NEC®-2023

ANALYSIS OF CHANGES

690.4(G) PV Equipment Floating on Bodies of Water

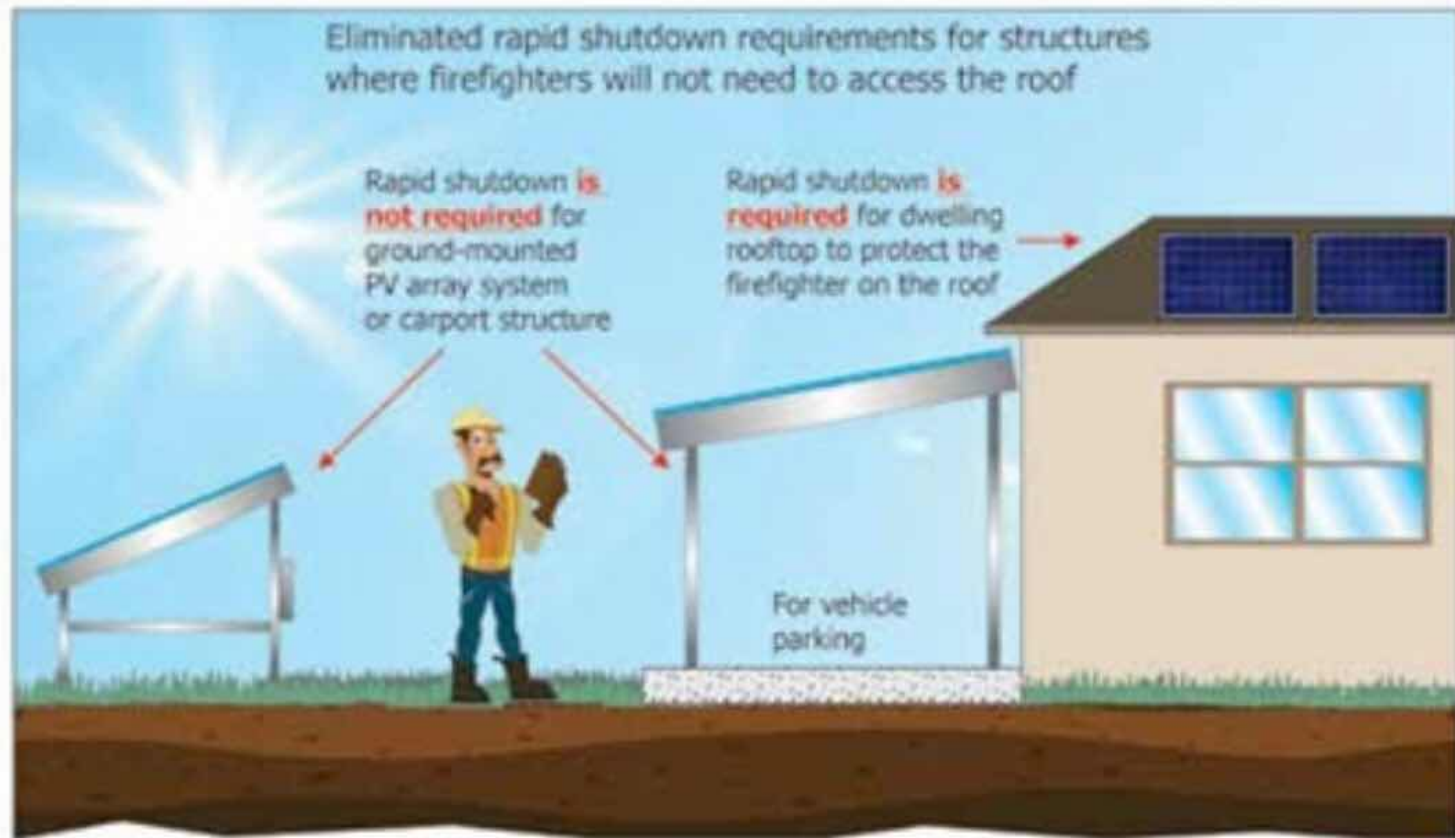
PV EQUIPMENT FLOATING ON BODIES OF WATER

Type of change: New

690.12(B)(2) Inside the Array Boundary

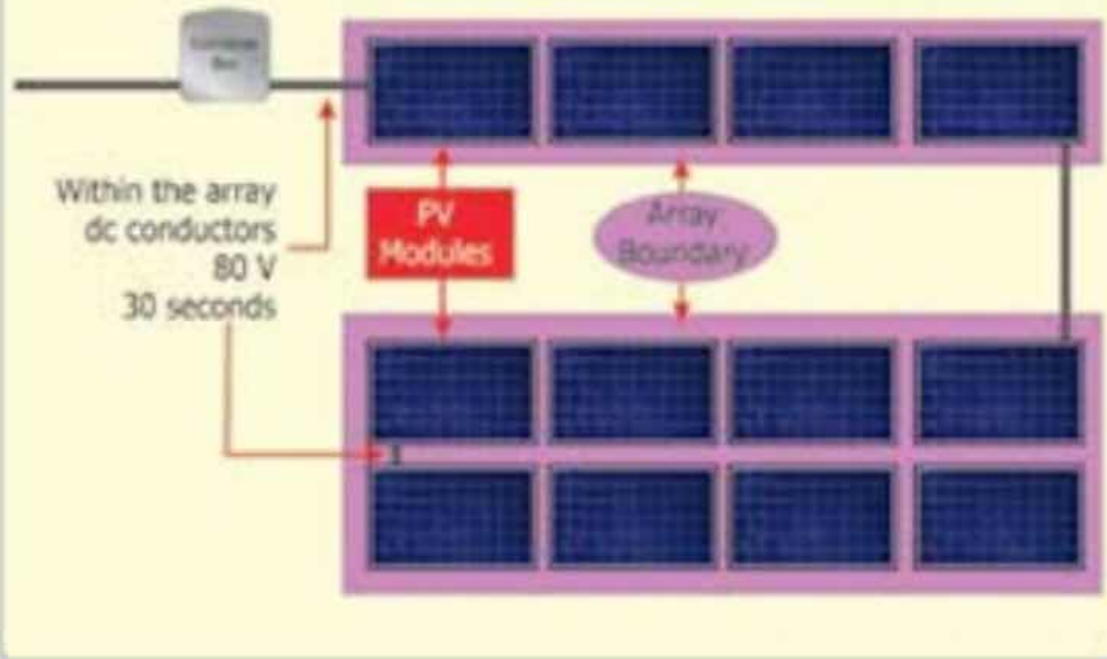
Two options were revised for rapid shutdown compliance inside the PV array

1st option

- PV shock hazard control
- **listed and labeled** per installation instructions

2nd Option

Reduce shock hazards to a maximum of **80 volts dc** within the array boundary and inside the PV equipment within **30 seconds**

Type of change: Revision
